London Luton Airport Expansion

Planning Inspectorate Scheme Ref: TR020001

**8.41 Surface Access Noise Modelling Additional
Information (Tracked Change Version)**

Application Document Ref: TR020001/APP/8.41

Drawing Title **Figure 1**
Change in 2043 Do-Something - Do-Minimum Daytime LAeq,16h Surface Access Noise Contours

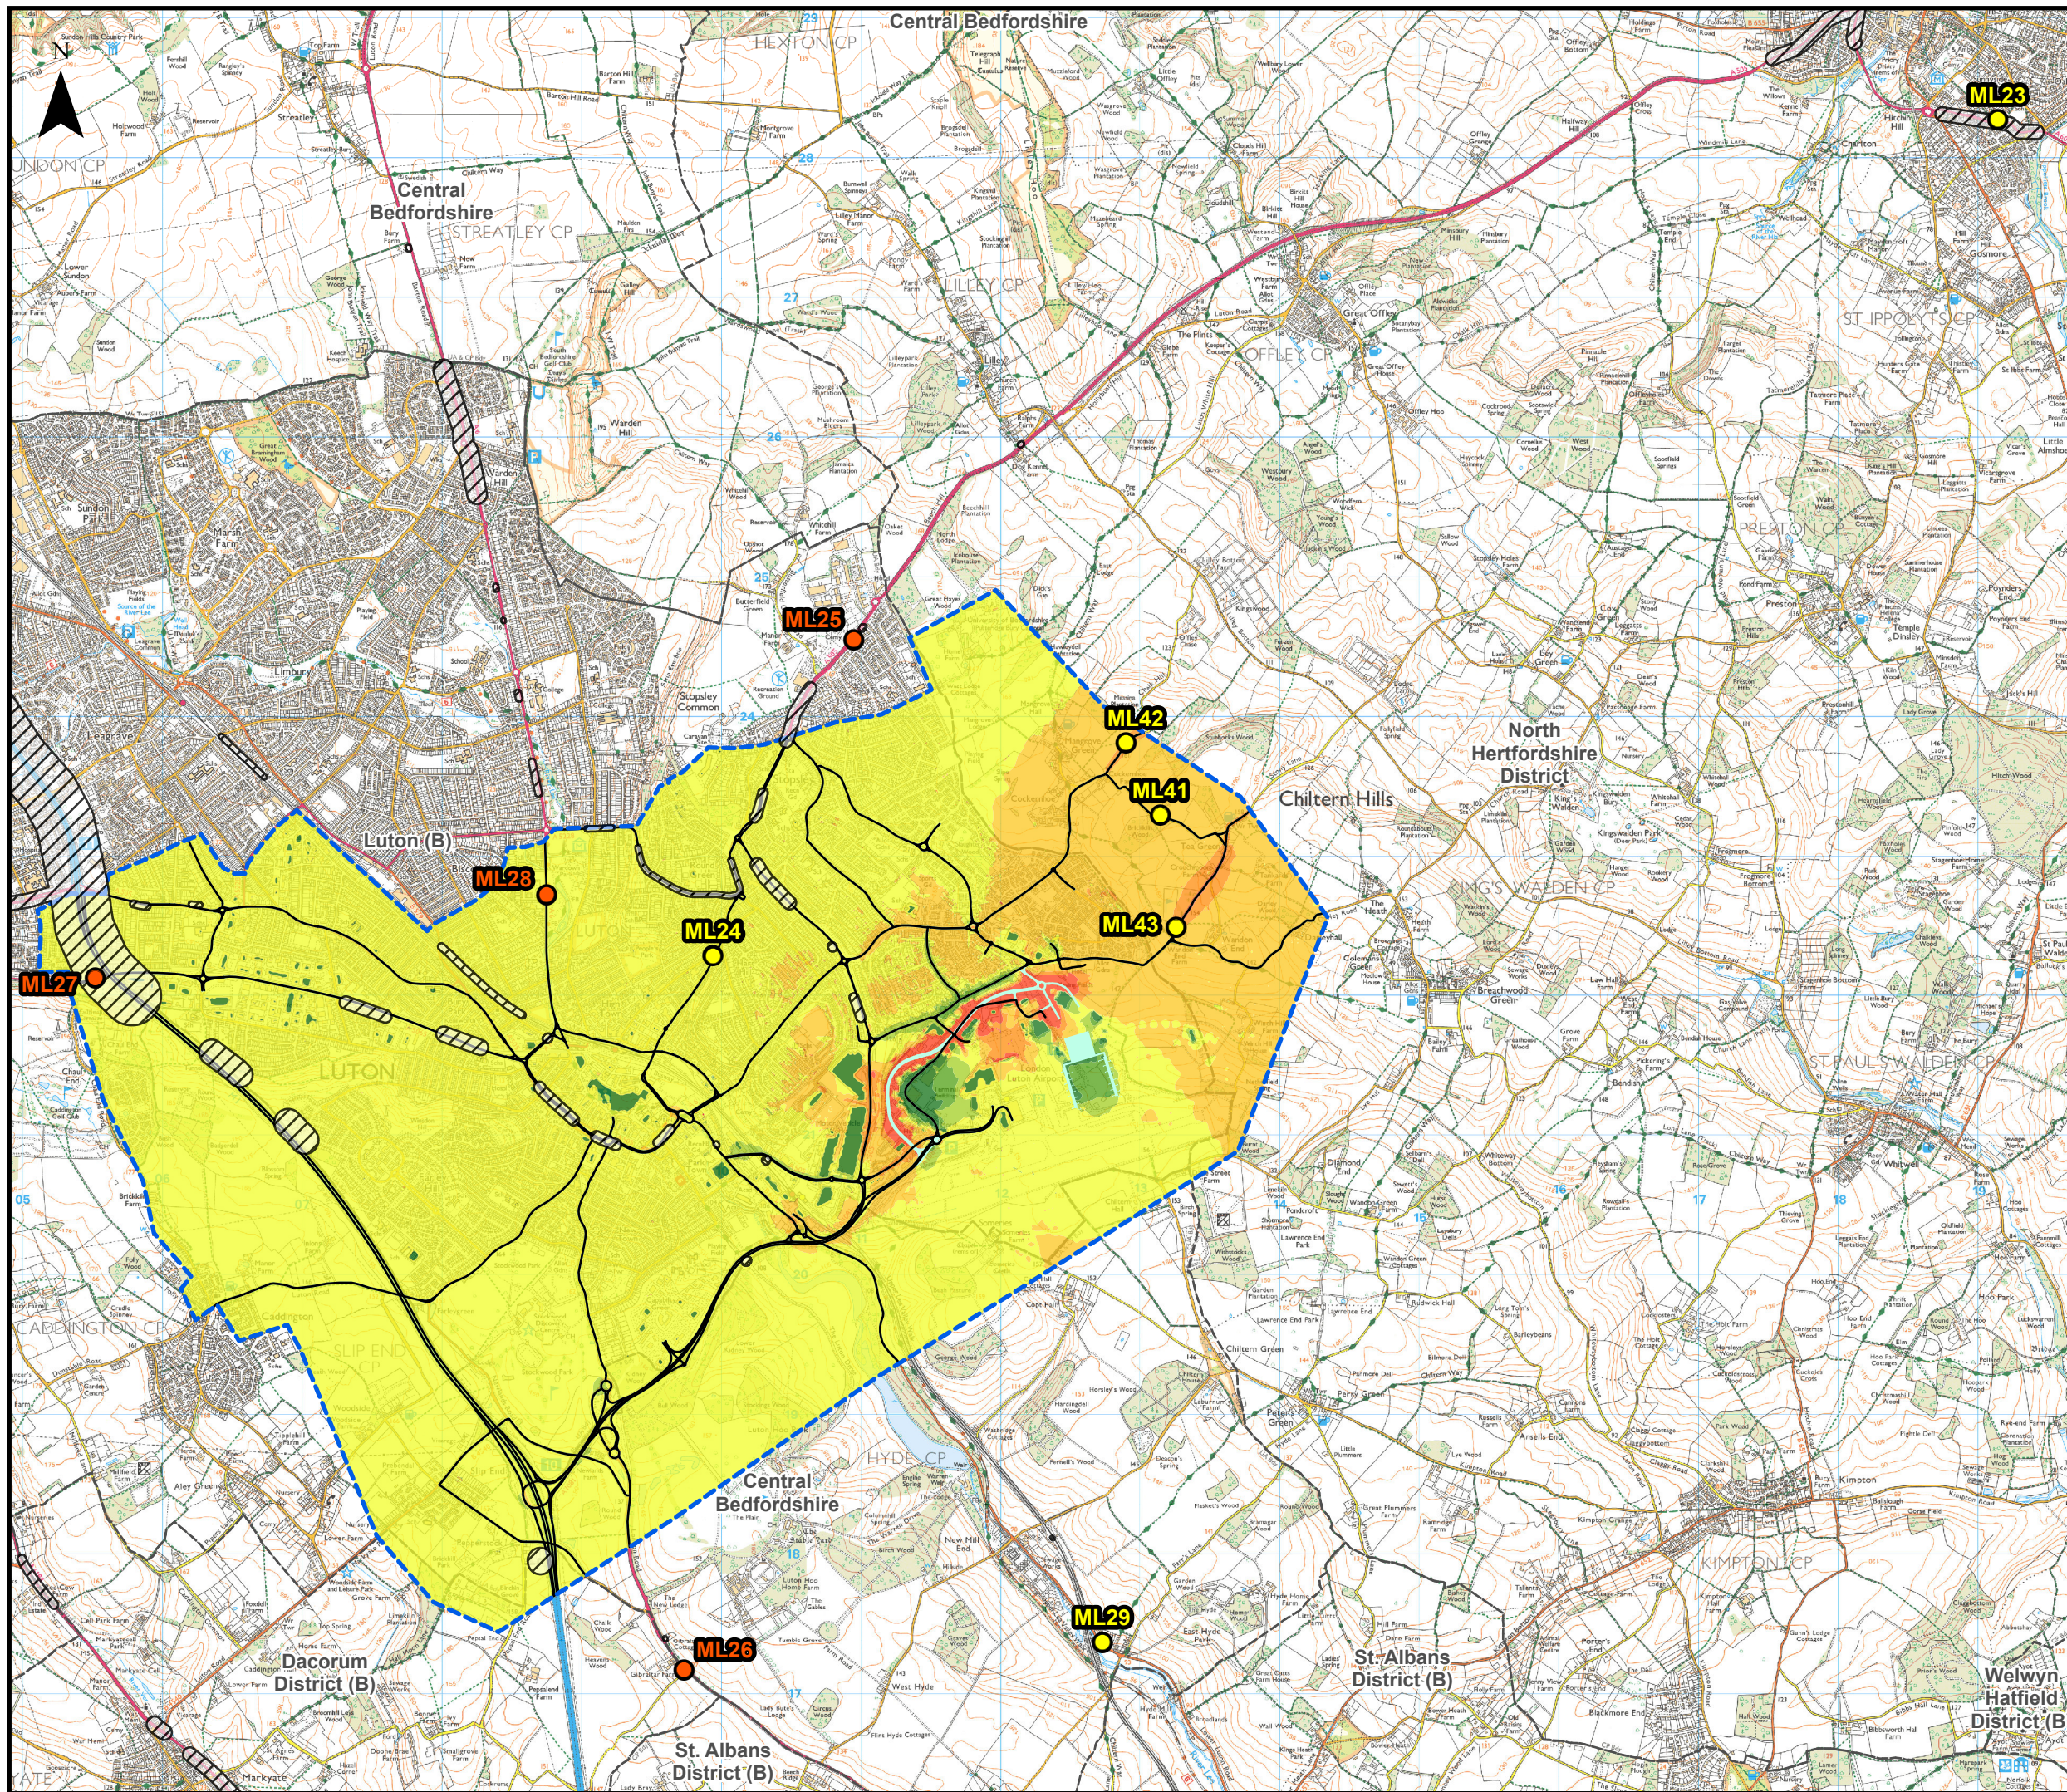
- 3.1.3 The HAs have also queried the validation of the surface access noise model, with references to instances where the measured and predicted values, with respect to the modelled baseline, differ by more than 3 dB. They recommend a clear explanation of these differences, and further justification for why the model can be relied upon.

- 4.2.4 It is noted by the HAs that at four of these 11 locations (ML25-28) the L_{Aeq,16h} derived from the measured sound levels differs by more than 3 dB from the L_{Aeq,16h} derived from the road traffic noise model.

4.2.10 Figure 1 and Figure 2 of this document show the monitoring locations overlaid on the surface access noise change contours for 2043. These figures show that the monitoring locations in question are either in areas expected to experience a negligible change in road traffic noise or outside of the surface access study area entirely². Given that localised corrections to the model would be applicable to both the Do-Minimum and Do-Something scenarios, the only change would be to absolute levels reported in the vicinity of these locations. And as explained in Section 4.1 this would not alter the conclusions of the assessment.

5.1.4 Figure 1 and Figure 2 within this document have been updated with the corrected survey locations (this has only affected ML25-28).

- 4.2.5 However, it should be noted that it is not standard practice to calibrate or adjust a road traffic noise model, representing annual average conditions, using data from short term three-hour measurements which are subject to particular traffic conditions on the day of measurement which may be atypical as well as requiring conversion to 16-hour levels based on assumed diurnal traffic patterns. Measured sound data will also record all sound sources at each location whereas the road traffic noise model only calculates the contribution from motorised vehicles. This uncertainty in one three-hour measurement is illustrated by the variability in sound levels at the long-term monitoring location. As can be seen from the measured levels reported in Table 16.25 of **Chapter 16 of the ES [AS-080REP1-003]**, there is a seven-decibel range in levels at the long-term position across one week. Given this range it is possible that modelled levels at all locations would be within 3 dB of the range of levels measured over the long-term.

5.1.1 Following submission of this paper at Deadline 2, further technical discussions were held between the Applicant and the HAs and their noise consultant. In these sessions, the four monitoring locations that had previously been queried due to discrepancies of greater than 3 dB (ML25-28) were discussed in detail, including a review of the locations using Google Streetview.

- a. planned survey locations were used in the spot-check exercise, however for these four locations the actual survey location was slightly updated on the day to due to survey practicalities;
- b. each of the four locations were 3-hour short term measurements which cannot be directly compared to long term annual average weekday model outputs (DMRB itself cautions the comparison of short-term measurements to long-term predictions at paragraph 4.2); and
- c. there were localised road surfacing conditions for each of the four locations that would influence the noise levels.

5.1.3 Following this exercise, the spot check exercise was repeated with the corrected actual survey locations, and details of the road surfacing conditions were provided to the HAs in writing, as per Table 5.1. As a result, it was agreed between the Applicant and the HA’s noise consultant that the discrepancies are due to locations specific factors, and it was agreed that the surface access noise model is appropriate. This will be recorded in the next update of the Statements of Common Ground.
